STAFF REPORT
(One-Step Final Plat)

CASE NUMBER: SUB 2005-32 -- GORGES' TIMBER RIDGE ADDITION

VICINITY MAP

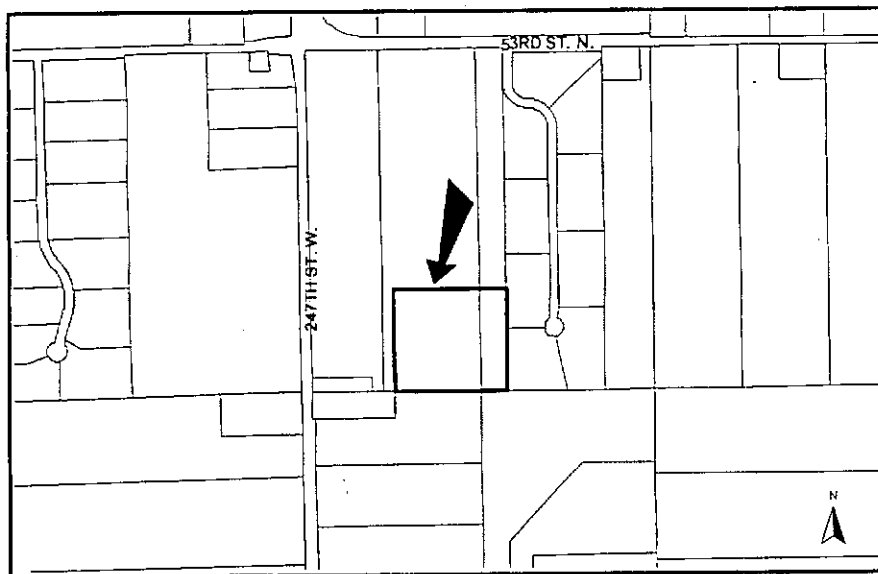
- D. County Engineering needs to comment on the status of the applicant's drainage plan. *A drainage plan is needed.*
- E. County Engineering recommends the plat be reconfigured to include all the property between these lots and 247th West and public access provided to all properties.

- F. In the event the applicant's proposed plat is approved by the Subdivision Committee, a restrictive covenant shall be submitted regarding the private ingress/egress easement which sets forth ownership and maintenance responsibilities and limits the private drive to servicing no more than three residential lots.

- G. Sedgwick County Fire Department requires that all access drives be in accordance with Sedgwick County Service Drive Code.
- H. Approval of this plat will require a waiver of the lot depth to width ratio of the Subdivision Regulations for the three lots. The Subdivision Regulations state that the maximum depth of all residential lots shall not exceed 2.5 times the width.
